HYDROLOGY FOR LAND-USE PLANNING: THE HILLSIDE AREA, ANCHORAGE, ALASKA

OPEN-FILE REPORT 75-105

Subject: PUBLICATIONS - Errata for U.S. Geological Survey
Open-File Report 75-105

Enclosed are errata sheets for Figures 28 and 30 of the subject report "Hydrology for Land-Use Planning: The Hillside Area, Anchorage, Alaska," by L. L. Dearborn and W. W. Barnwell. You may wish to insert them in your copy of the report.

Figure 28.--Relative susceptibility of water resources to pollution by liquid waste disposal.

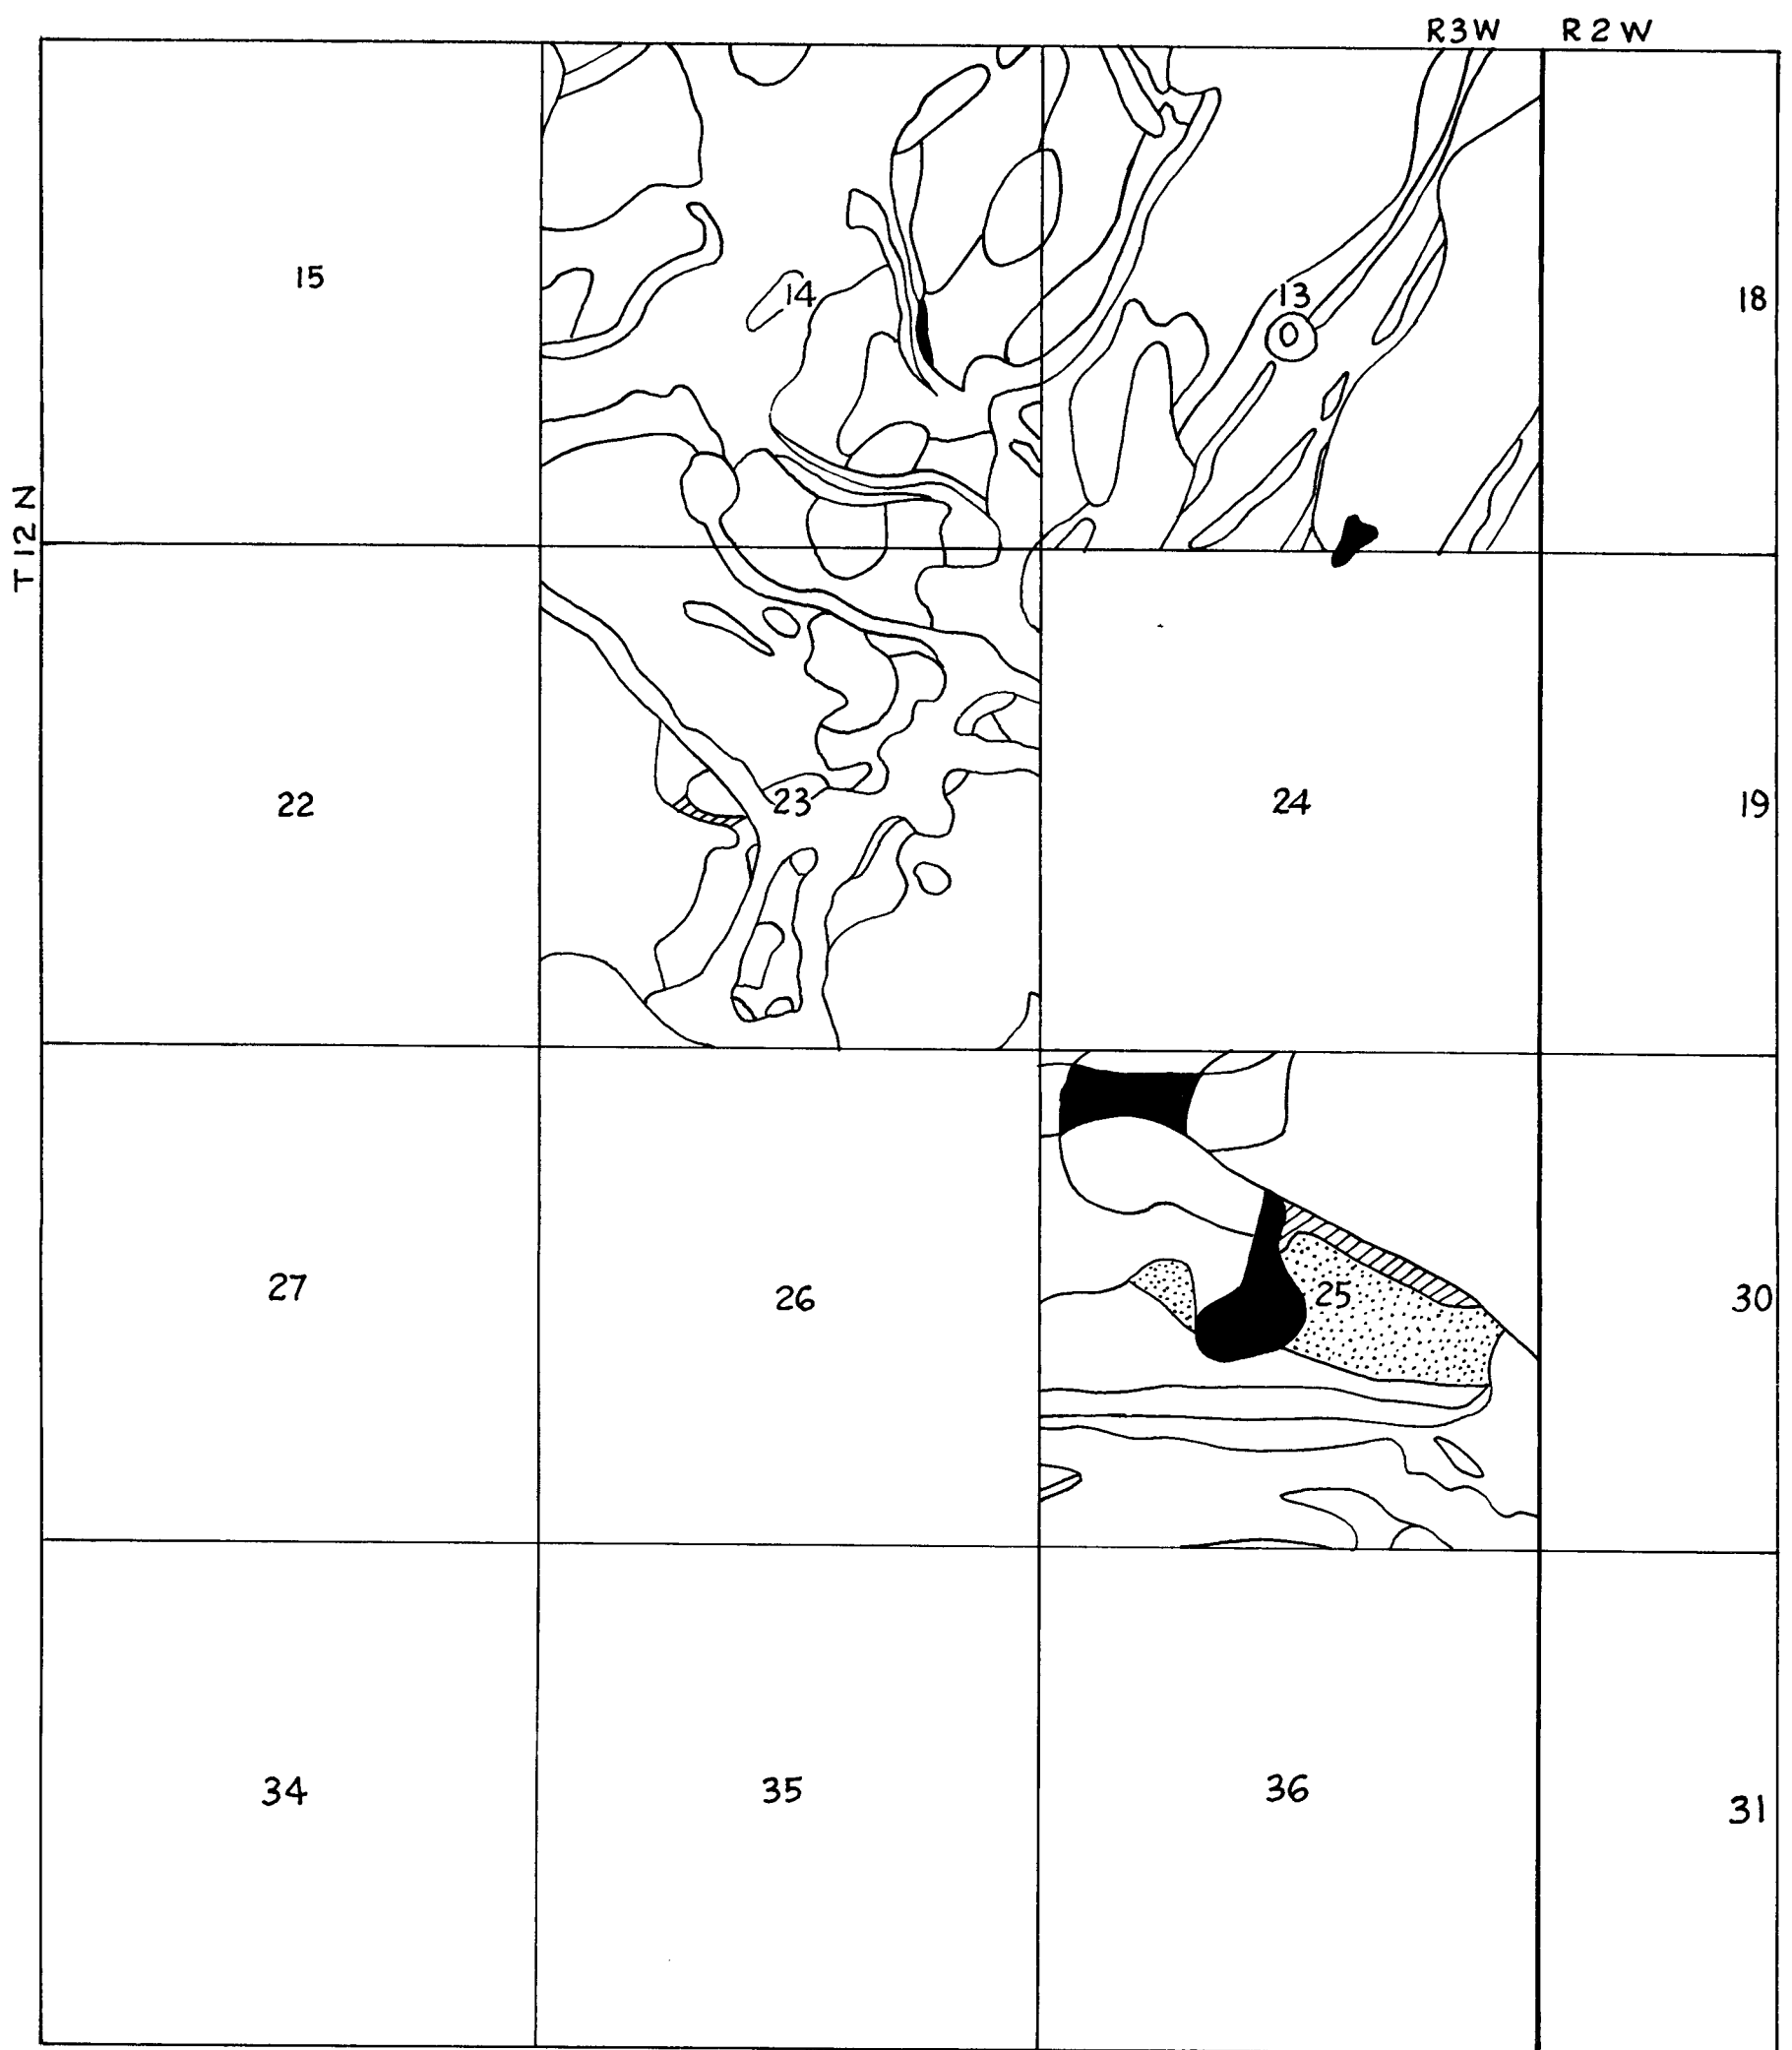
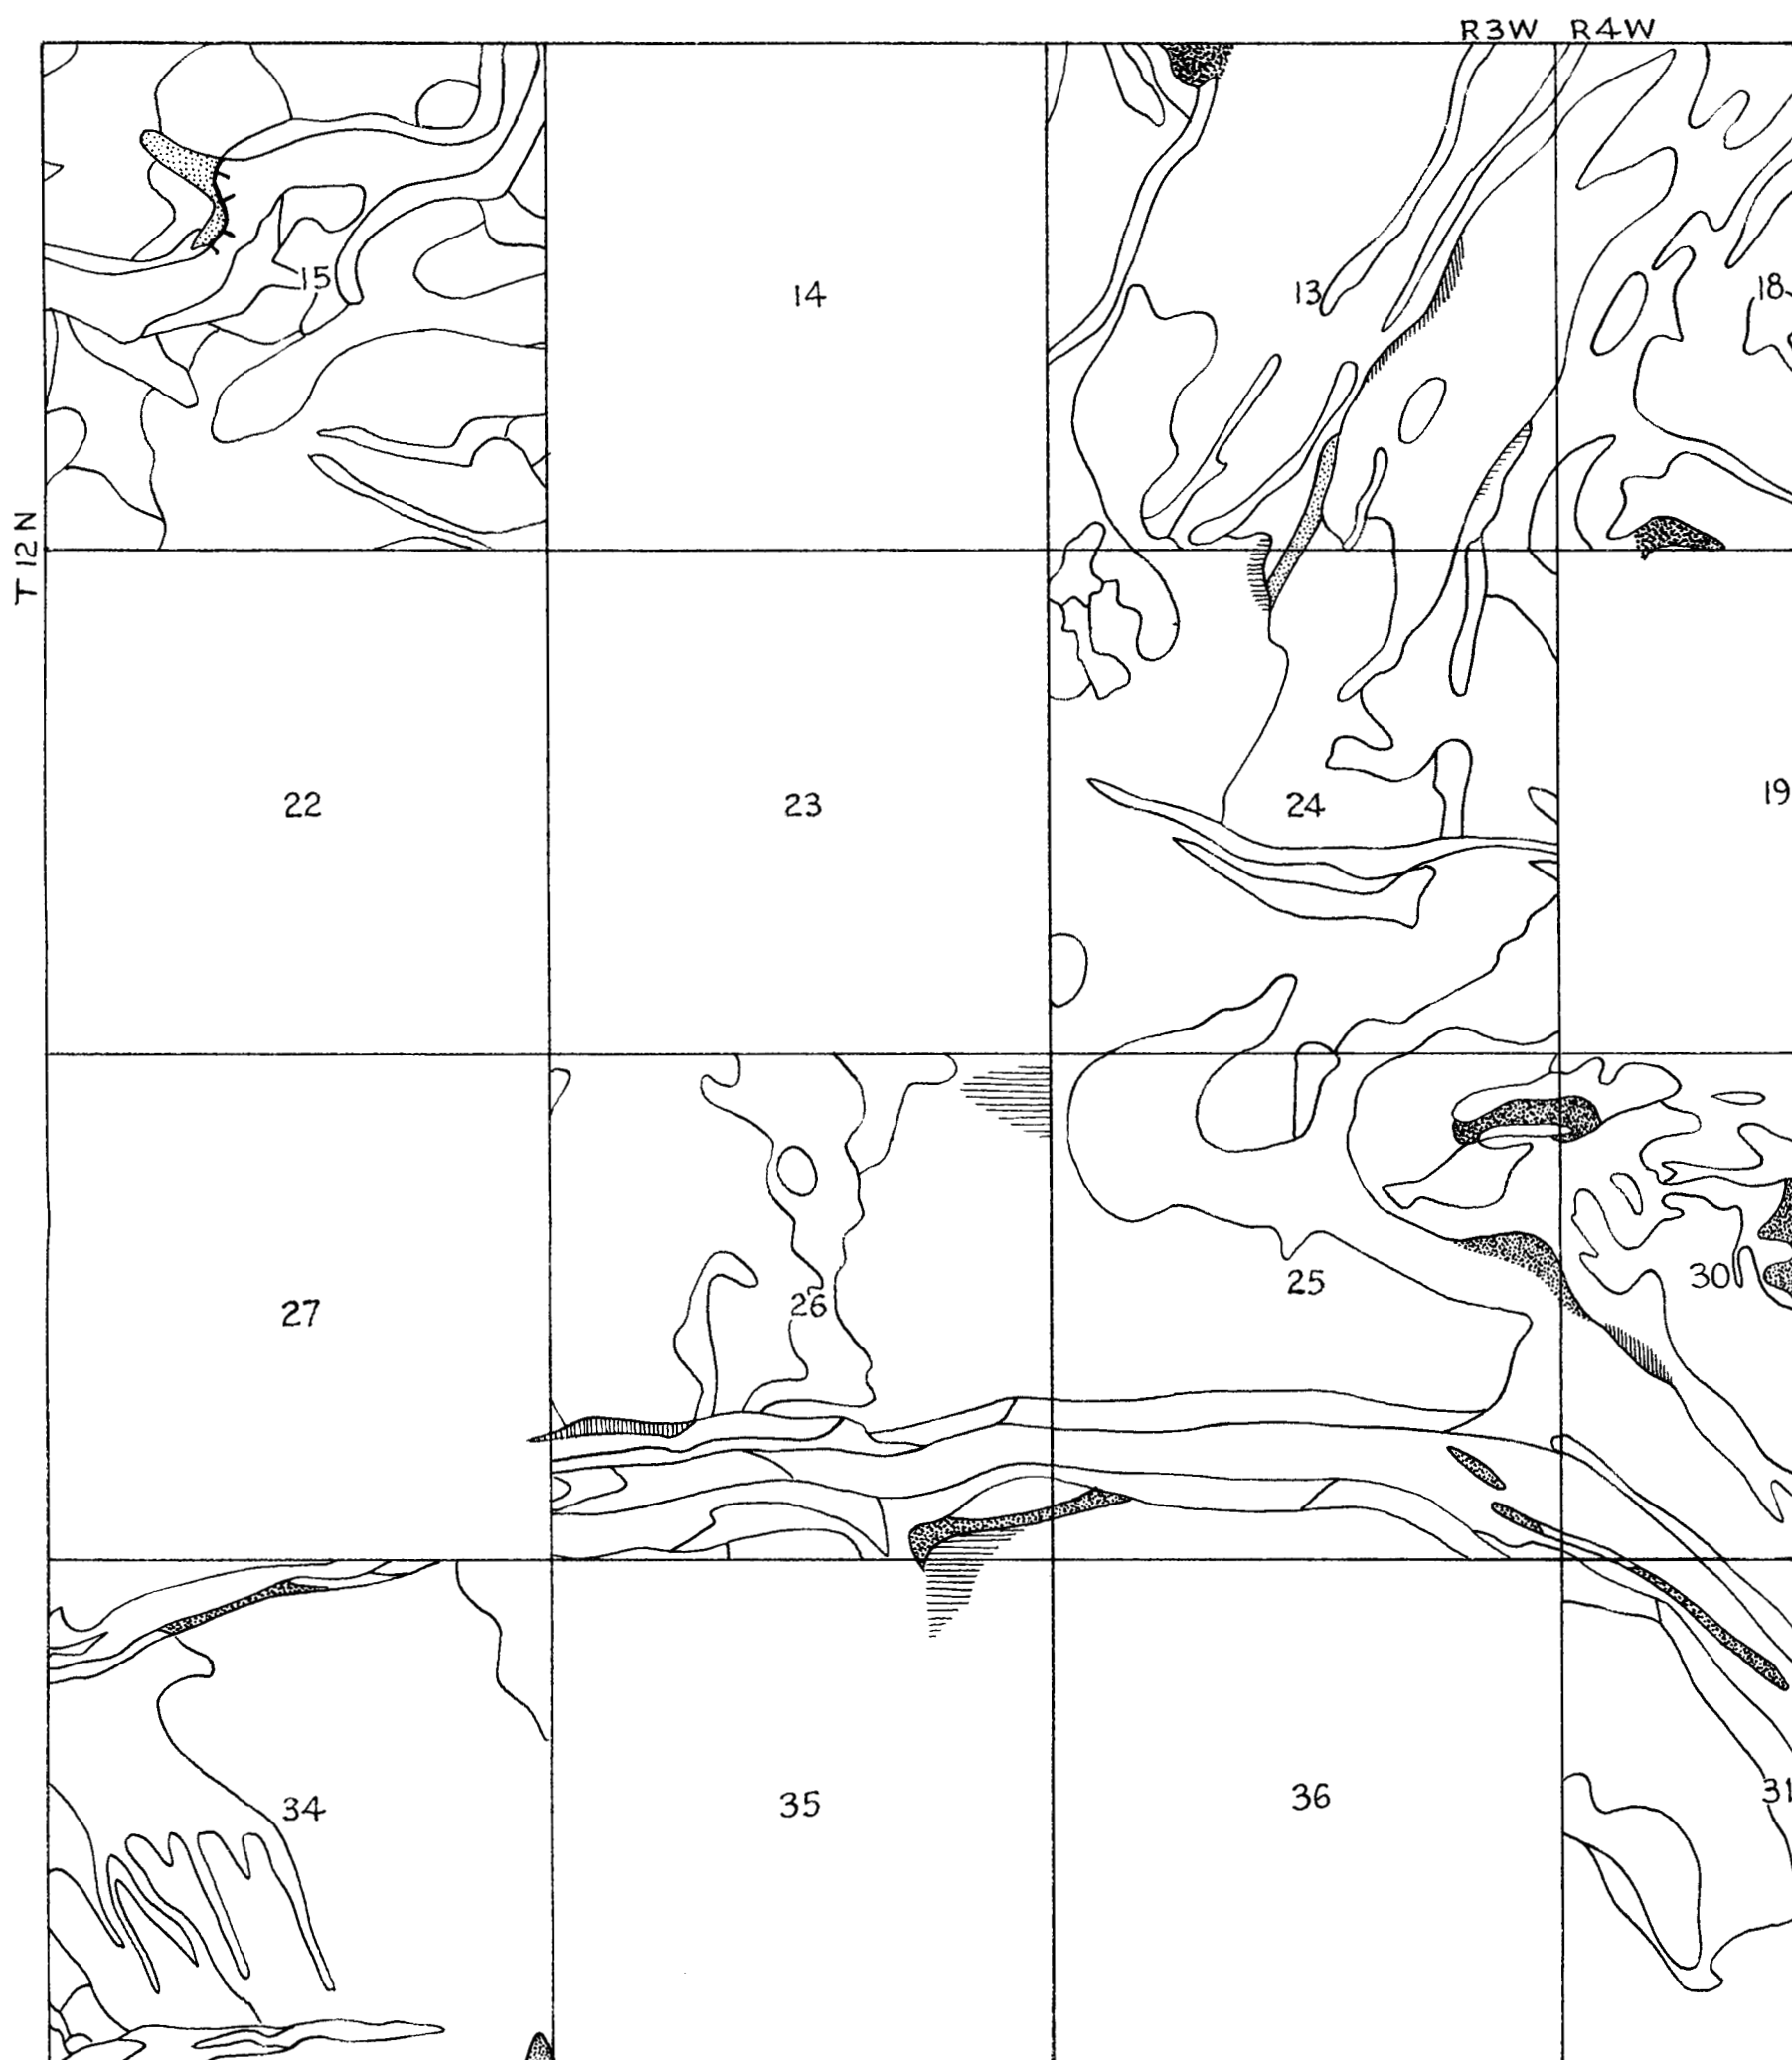
Changes on page 28 of report.

Change to purple - High

Change to blue - Low

Change to white - Very Low

Figure 30.--Generalized landslope and sediment thickness near mountain front.
 HYDROLOGY FOR LAND-USE PLANNING: THE HILLSIDE AREA, ANCHORAGE, ALASKA
 By Larry L. Dearborn and William W. Barnwell
 Open-File Report: 75-105, 1975

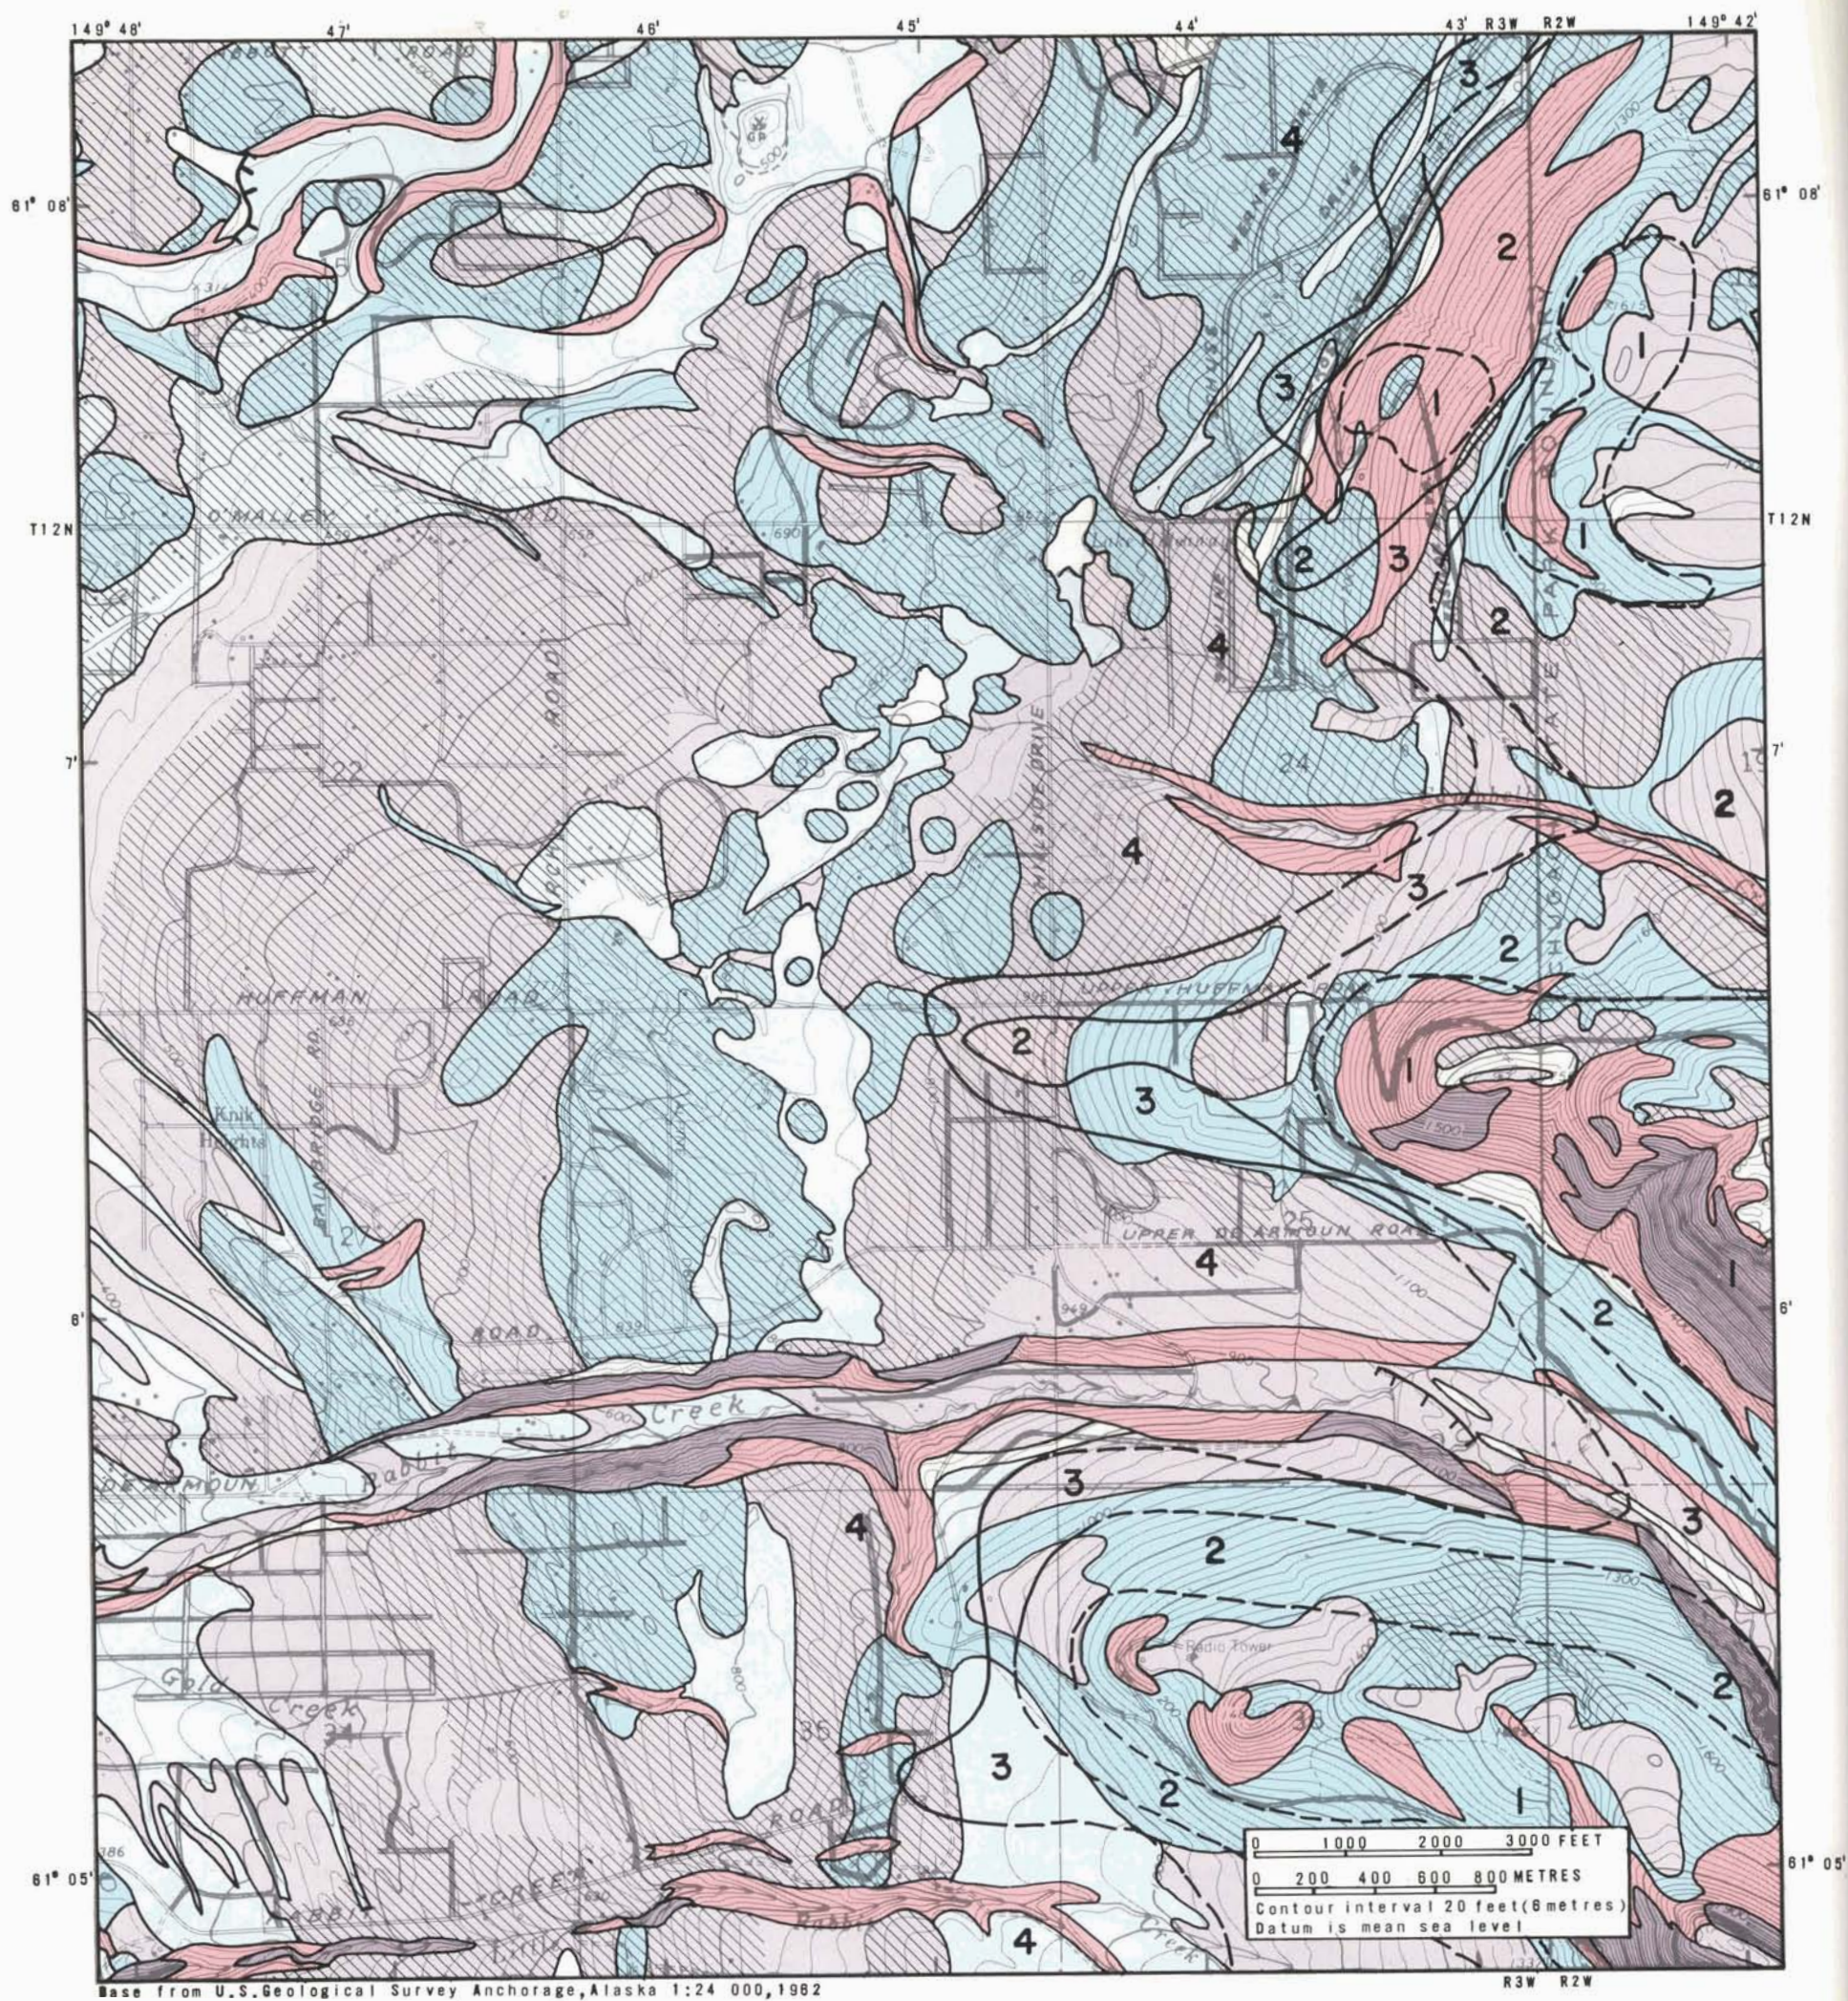
Changes on page 30 of report

Change to light blue--less than 5 percent

Change to dark blue--15-25 percent

Change to lavender--5-15 percent

Change to pink--25-45 percent
